RESCUE HOOK ASSEMBLY

P.A. NAVY - AS Other Cust (E)	TITLE HOOK, HELICOPTER RESCUE	MILITARY STANDARD MS18027(AS)
PROCUREMENT SPECIFICATION MIL-H-23599(AS)	SUPERSEDES: AGEL 5-952	SHEET 1 OF 6

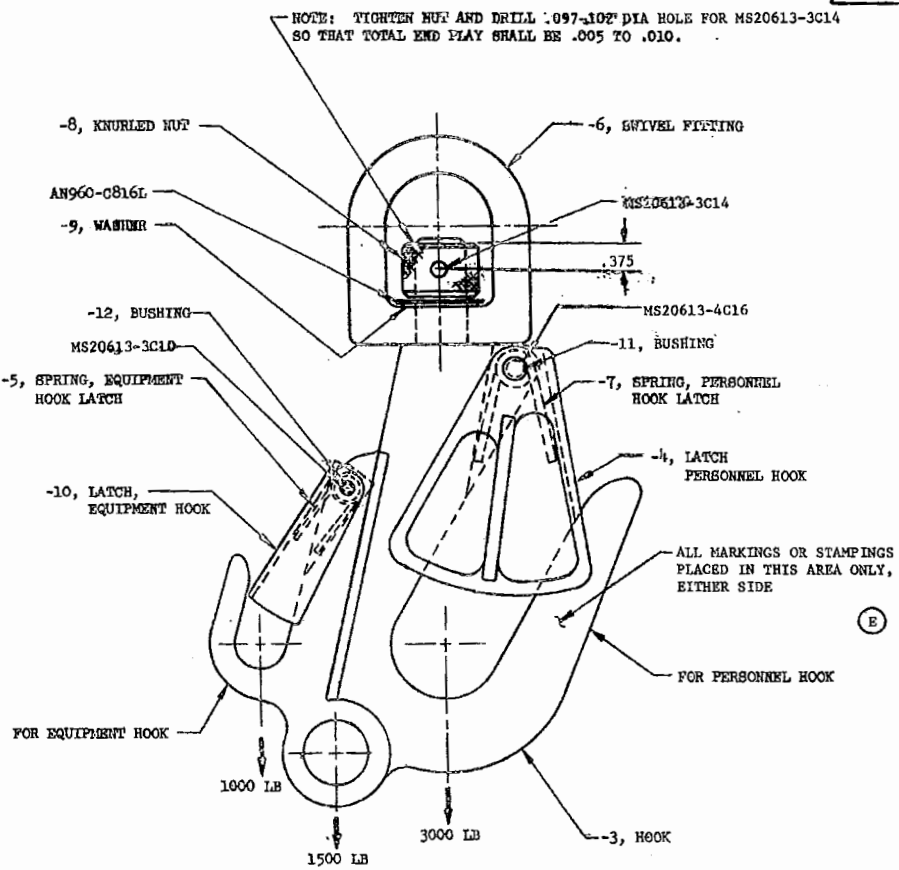
DASH NO.	RESCUE HOOK ASSEMBLY INCLUDING PARTS:
~~-1 (a)~~	~~AS SHOWN~~
-2	WITHOUT -6,-8,-9, AN960-C816L & MS20613-3C14
-2A	AS SHOWN

~~(a) RESCUE HOOK MS18027-1 WAS PREVIOUSLY IDENTIFIED AS MS18027; INTERCHANGEABILITY WAS NOT AFFECTED BY THIS REIDENTIFICATION.~~

MS18027-1 IS NOT SUITABLE FOR USE, USE MS18027-2A (SAFETY INVOLVED)

(E) APPROXIMATE WEIGHT OF MS18027-2A IS 1½ POUNDS.

-3 HOOK

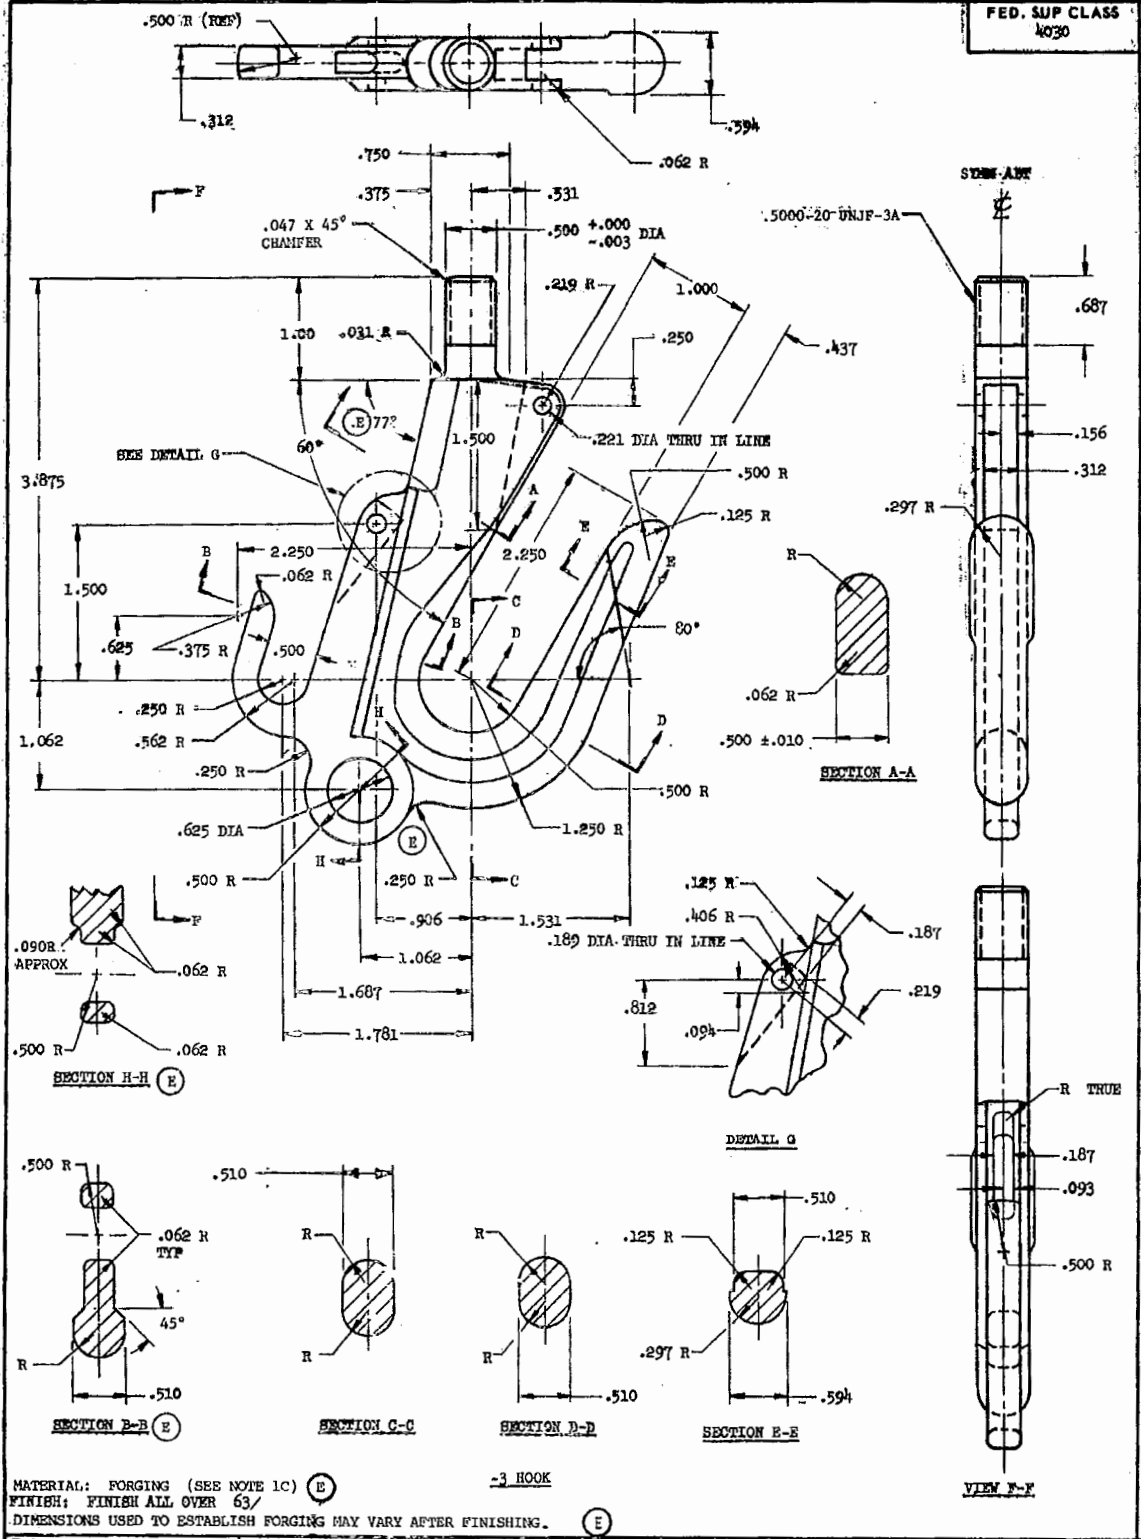
MATERIAL: FORGING (SEE NOTE 1C) E
FINISH: FINISH ALL OVER 63/
DIMENSIONS USED TO ESTABLISH FORGING MAY VARY AFTER FINISHING. E
